Trade Winds Farm Subdivision

Winchester, Connecticut

Environmental Review Team Report

Report No. 323

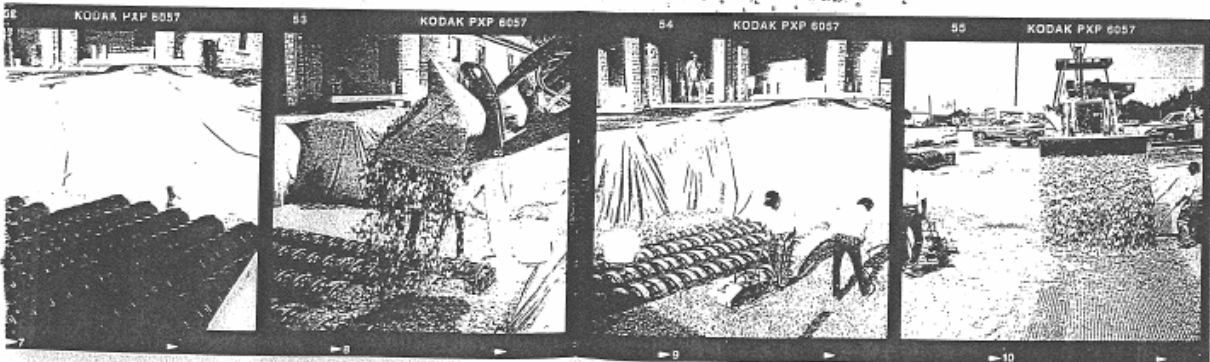
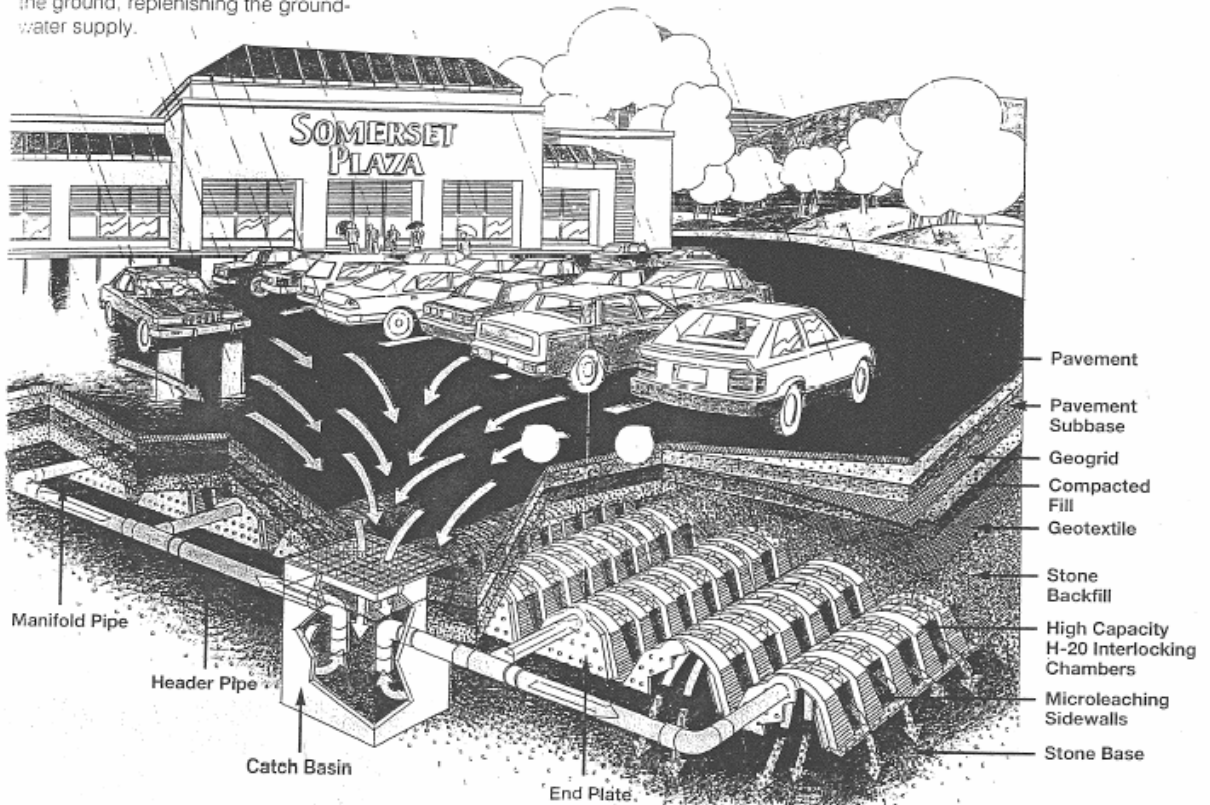
- The Commission should require that a specially designed catch basin be installed just before the infiltration chambers (see attached diagram). This catch basin should be designed to fail when sediments reach a certain height. This will eliminate sediments from entering the infiltration chambers, which will quickly reduce storage capacity and eventually cause the system to fail. The developer needs to name a responsible party for the maintenance of the entire stormwater systems. Then the Town should require a performance bond to carry out maintenance activities after construction activities are complete if the designated party fails to maintain the storm water system.
